From: Gerard Tuckerman <Gerard.Tuckerman@MidCoast.nsw.gov.au>
Sent: Wednesday, 15 August 2018 6:44 PM
To: 'bob@tatland.com.au'; Bruce Moore
Cc: Ledum Yorgure
Subject: RE: Riverside - Channels

Thanks for the time today to discuss and resolve the outstanding issue associated with the existing Myall Quays water quality basin 8c and the southern floodway within the modified Riverside Concept layout. I commend you and Adrian on the professional approach taken by providing analysis based on checking and running the flood models to determine velocities, water levels and storm events which would drive flows within the south branch floodway. The evidence based approach provides confidence to Council that the existing water quality treatment provided by basin 8C for several lots in Leeward Circuit can be suitably modified to ensure that there is no net change in treatment of the existing stormwater discharge as part of the final design of the south branch floodway. The commitment to undertake replacement action of the basin function within Stage 1 and the design work in the first overall DA for the development is satisfactory.

RE: HYDROLOGICAL COMMENTS IN RESPONSE TO COUNCIL'S LETTER OF 19

FLOODWAY LONGITUDINAL SECTIONS COMPARISON

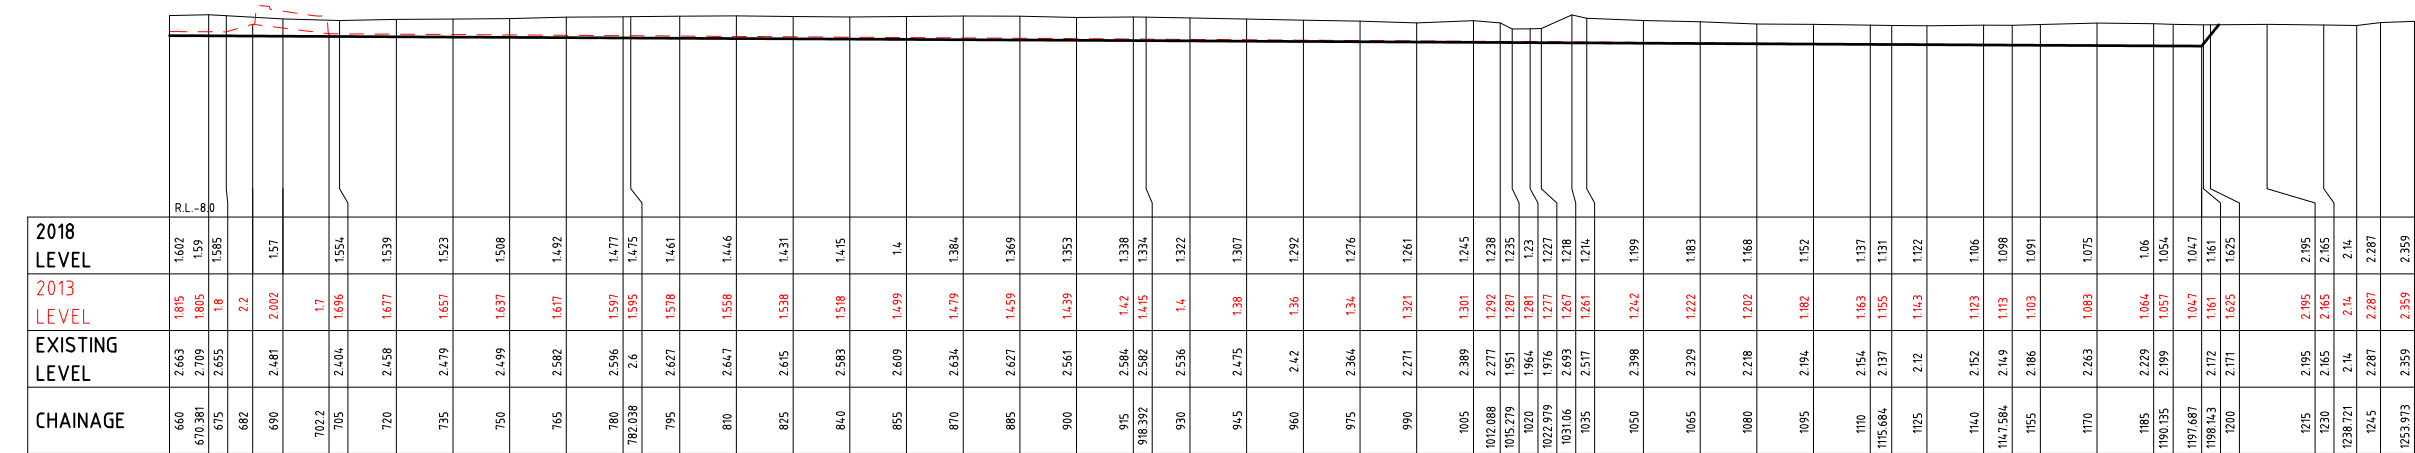
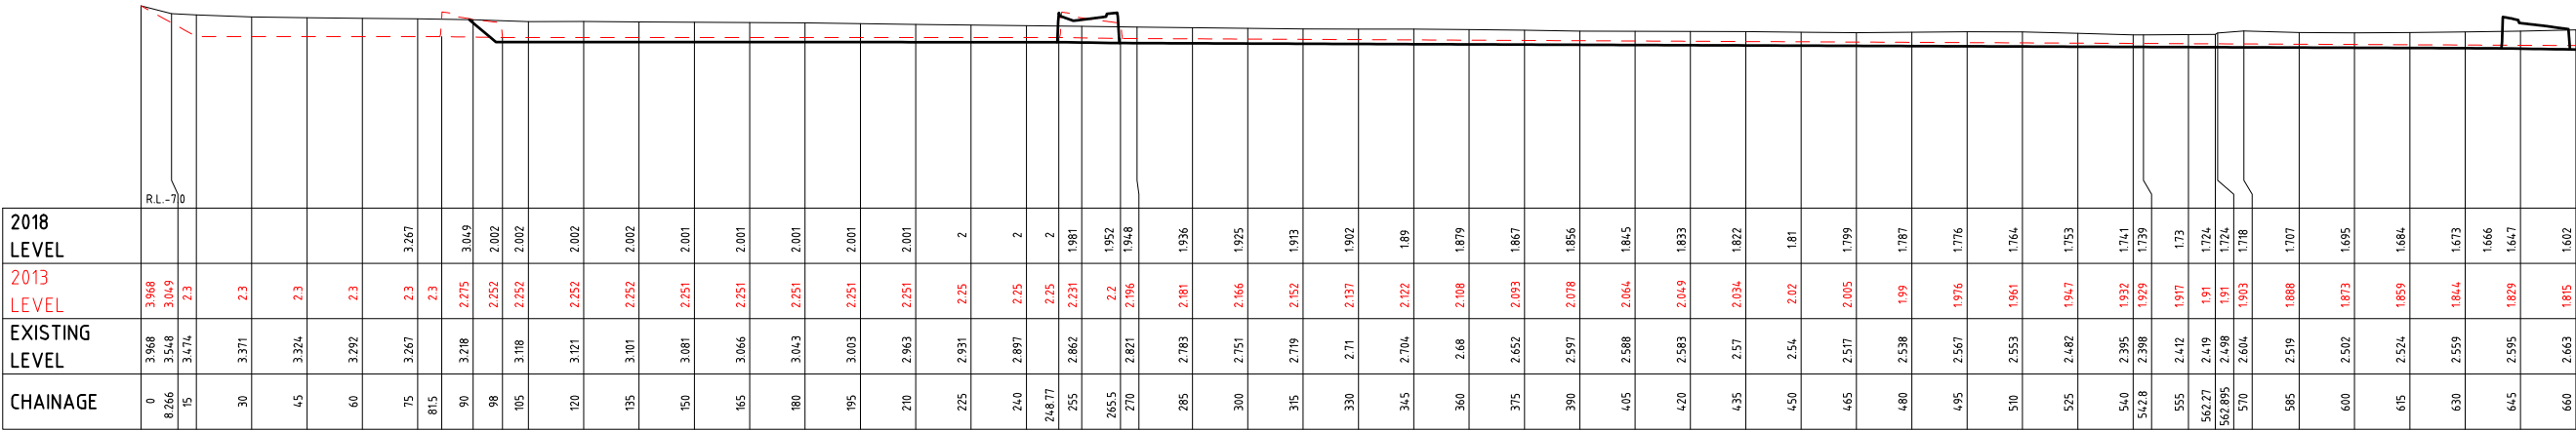
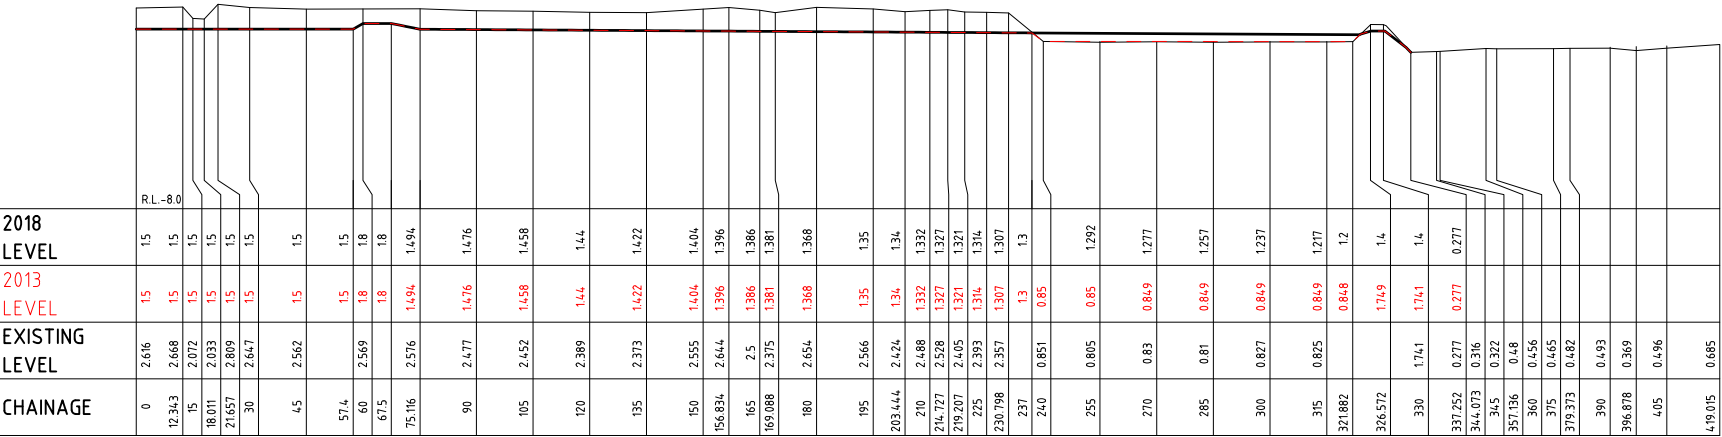
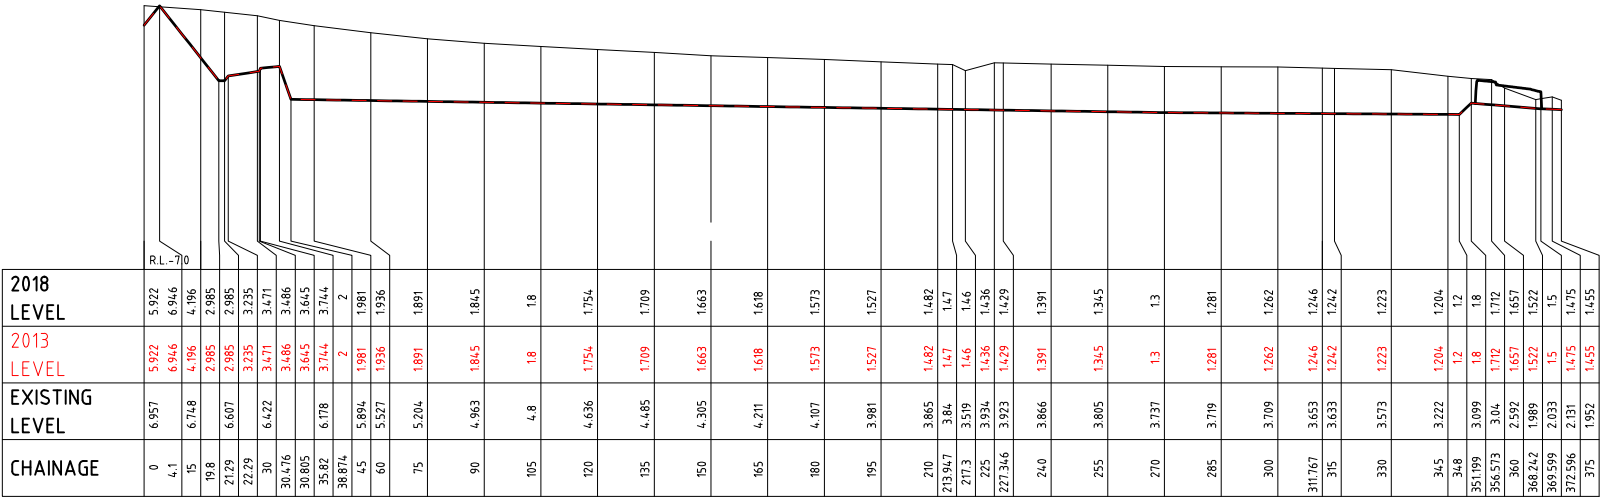
- South Branch – Levels and location remain unchanged, other than the removal of the existing basin at the bottom of this corridor – was included in the 2013 modelling as existing but not part of approval.

- West Branch – location unchanged (although upstream end truncated by 90m). Levels unchanged at bottom of site, progressively deepened up to 250mm lower at top end of site. I believe the only place any of these levels appear in the application documentation is where culvert invert levels are noted on the "Preliminary Drainage Design Details" plan as Attachment 1A to the Martens Concept IWCMS report – The document accompanying the modification shows the West Branch upper culvert as U/S Inv 2.0, D/S Inv 1.95m where the document accompanying the approval shows U/S 2.25m, D/S 2.2m. This is the area shown in Figure 18 (reproduced in Daniels email below) as greens so the lowering would just bring it back down to groundwater level. Also note the red area in Figure 18 at the top of this branch is the area now truncated by the modification.

Figure 1: Approved cut and fill plan (reproduced from Figure 6 at page 13 of the 2013 approved concept stormwater management plan).

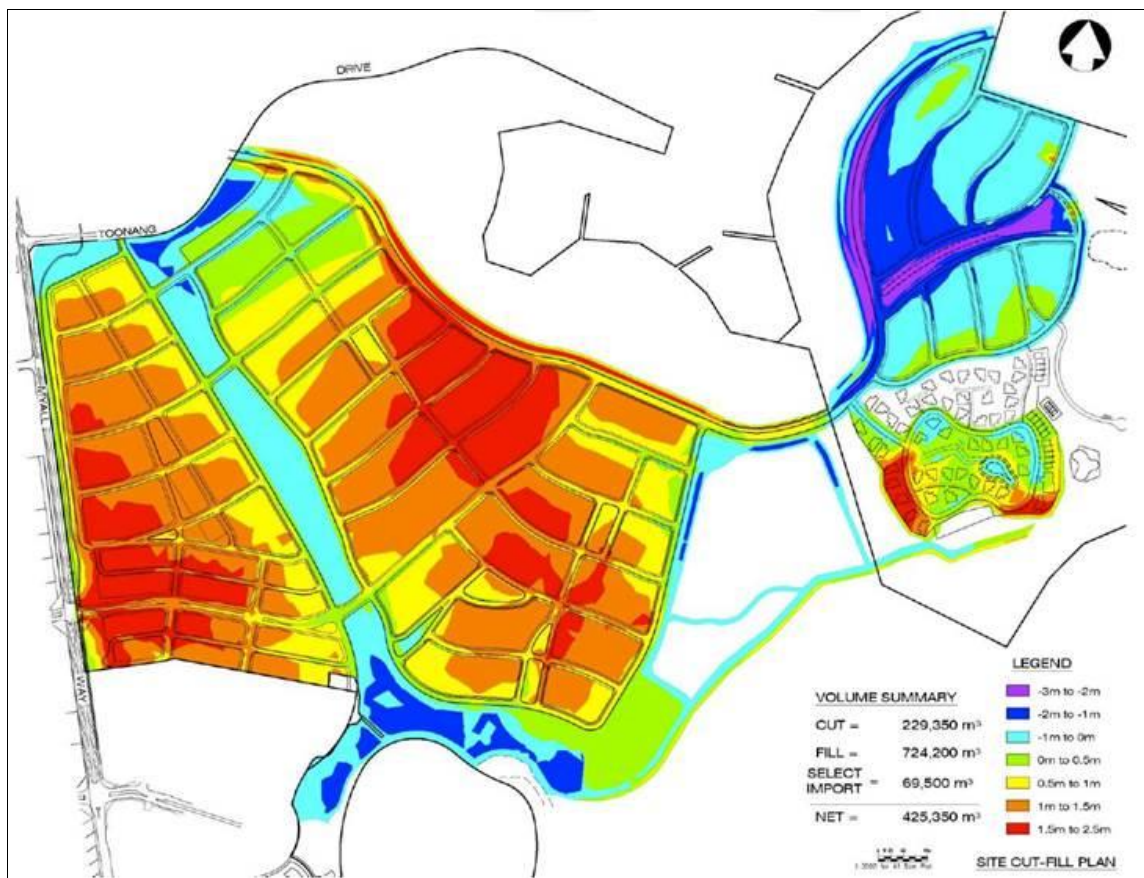
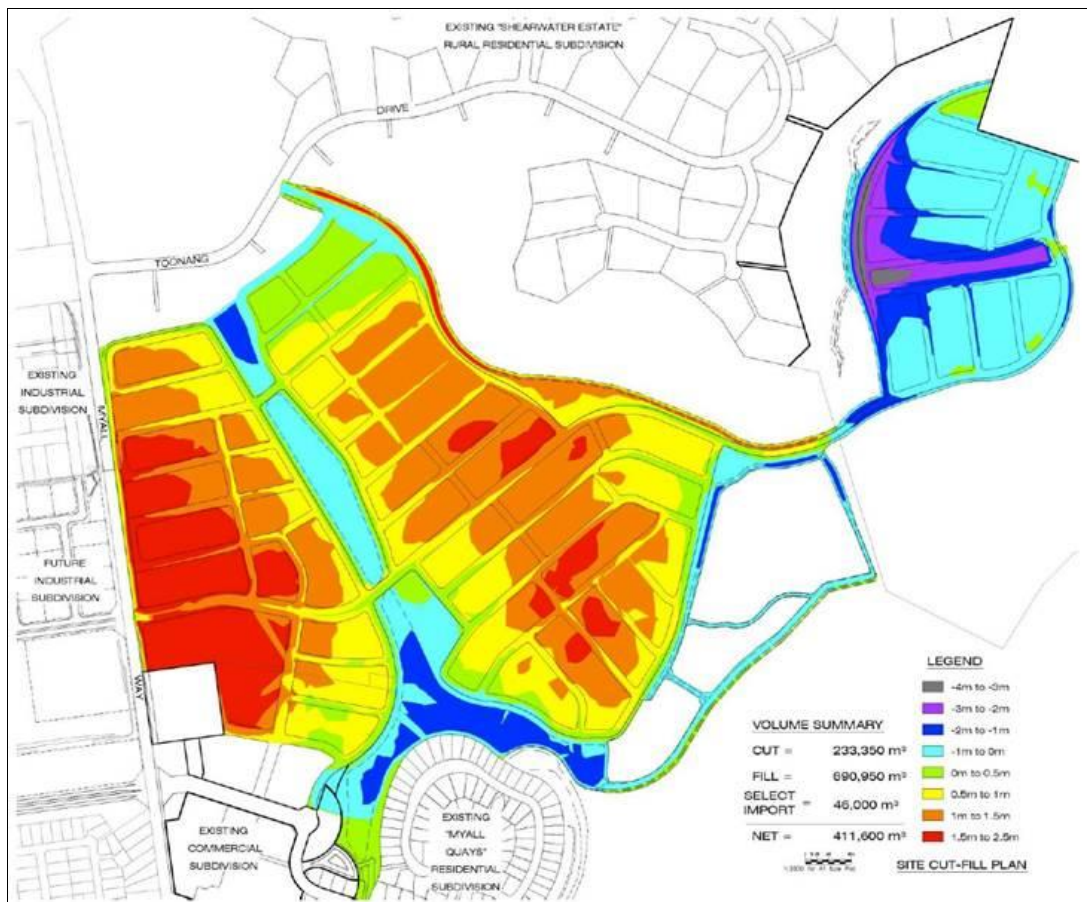
- b. On Figure 6 at page 13 of the 2013 approved concept stormwater plan, the approved site cut-fill earthworks are shown. A copy of this figure is provided in Figure 1 at Attachment A and indicates extensive areas where cut has been approved.

- d. The cut-fill earthworks for the concept plan modification application is shown in Figure 6 at page 16 of the 2015 proposed concept stormwater management plan, and is reproduced in Figure 2 at Attachment A. It is

evident from comparing the approved and proposed cut-fill earthworks plans, that the two plans are nearly identical. Importantly, both plans show areas of significant cut within the proposed drainage system.

- c. Based on our review of the 2015 proposed concept stormwater management plan, the proposed earthworks are consistent with the 2013 approved earthworks for the development site. We are of the view that the surface and groundwater impact assessment undertaken for the 2013 approved CIWCMS is therefore consistent with the proposed concept plan modification.

Figure 3: Window Lakes (reproduced from Figure 18 of 2013 approved CIWCMS).

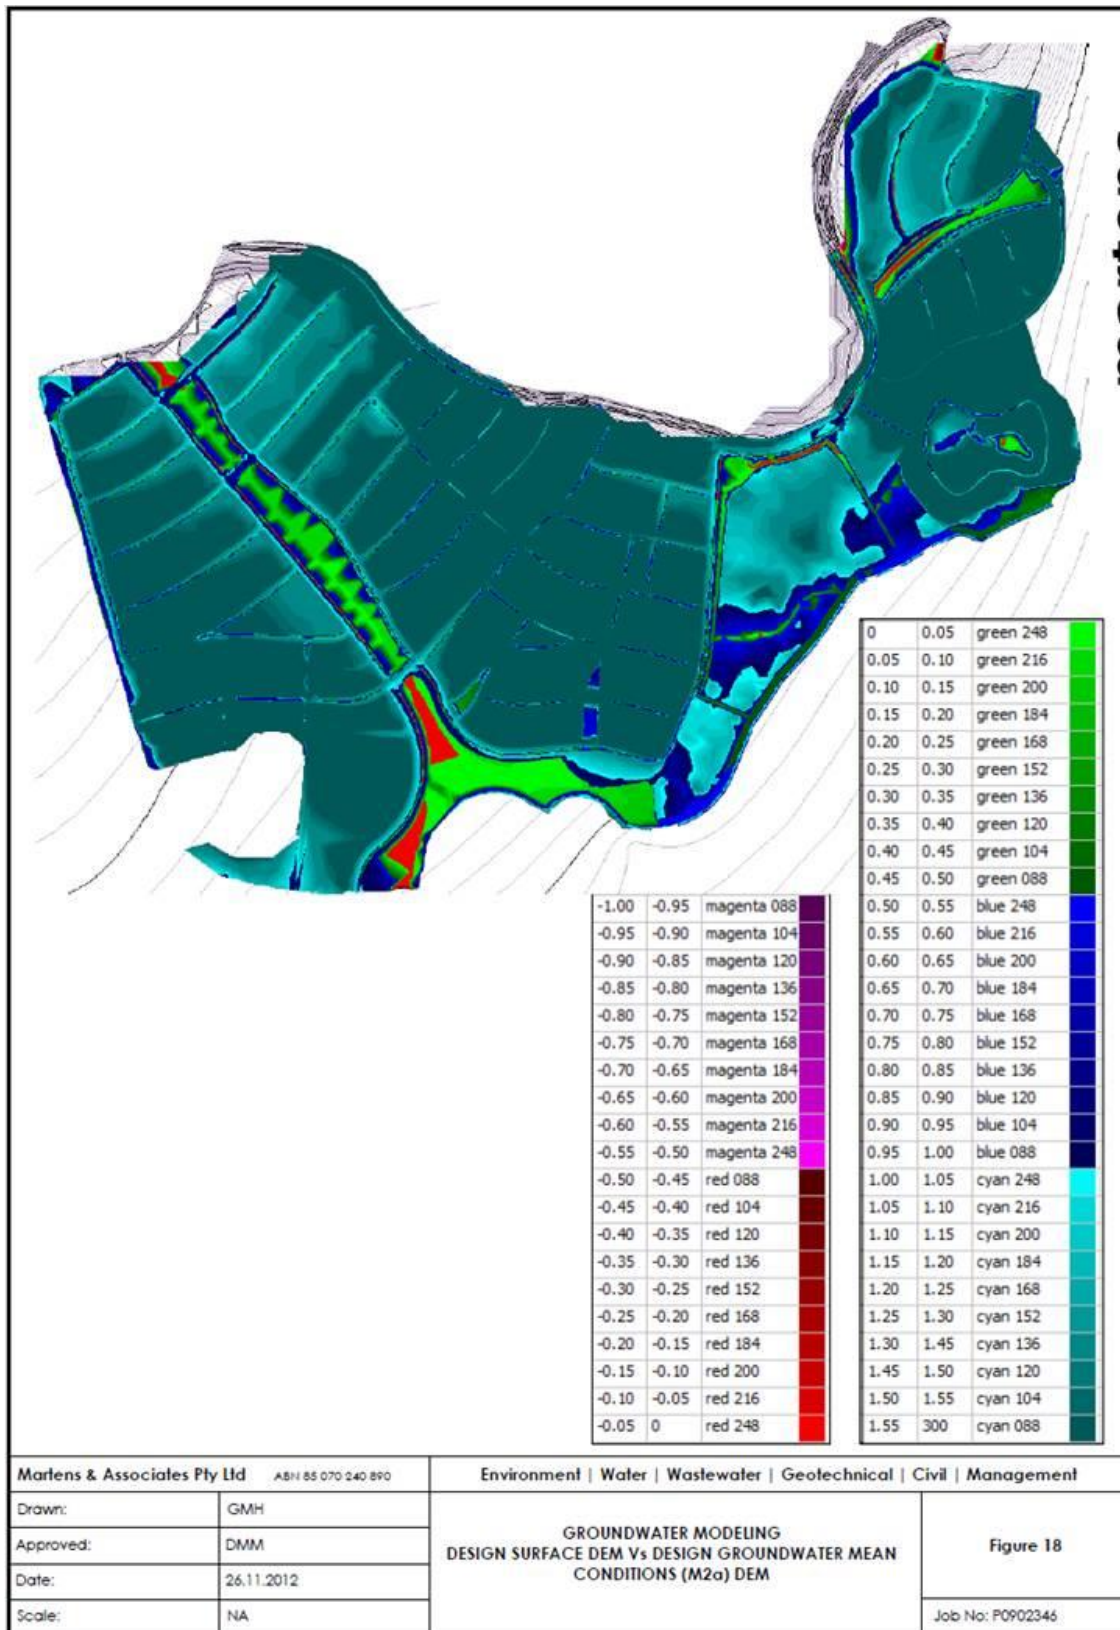
4. In respect of Council's concern over intersecting the groundwater table, the following is noted:
 - a. The 2013 approved CIWCMS included groundwater modelling that incorporated the effects of the development intersecting groundwater at a number of locations. The creation of 'window lakes' was the subject of extensive discussions between the applicant, its consultants (which included Martens & Associates), the department and the PAC, and the approval includes some limited allowance for the creation of these features. This can be seen for example in Figure 18 of the 2013 approved CIWCMS (this is reproduced in Figure 3 at Attachment A), which shows where mean groundwater levels would be intersected by the development terrain and drainage system (shown as red and magenta).
